Working Party on Noise

Regulation No. 59 (Replacement silencing system)

Proposal for draft amendments to Regulation No. 59

Submitted by the expert from the European Association of Automobile Suppliers *

Test apparatus

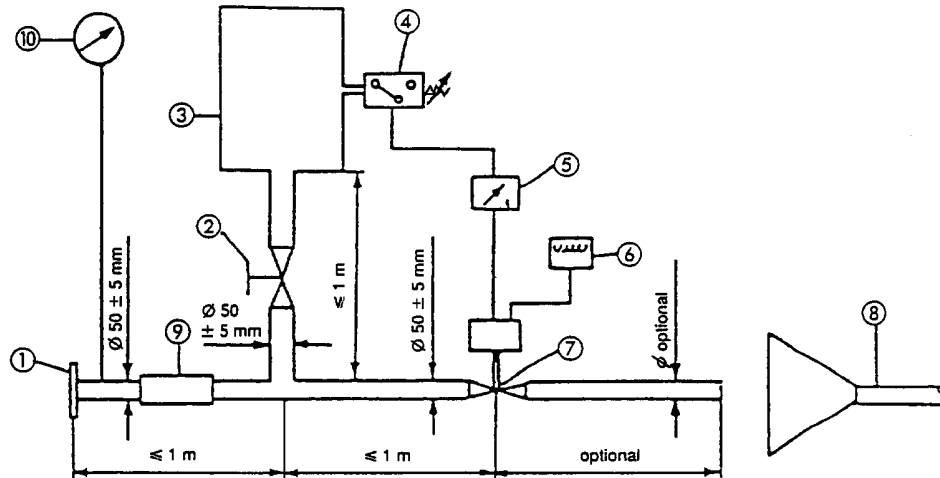
- 1 Inlet flange or sleeve – connection to the rear of complete silencing system to be tested.
- 2 Regulation valve (hand operated).
- 3 Compensating reservoir from 35 to 40 l.
- 4 Pressure switch **5 kPa to 250 kPa** – to open item 7.
- 5 Time delay switch – to close item 7.
- 6 Counter of impulses.
- 7 Quick response valve – such as the valve of an exhaust brake system of 60 mm in diameter, operated by a pneumatic cylinder with an output of 120 N at **400 kPa**. The response time, both when opening and closing, **shall** not exceed 0.5 s.
- 8 Exhaust gas evacuation.
- 9 Flexible pipe.
- 10 Pressure gauge.
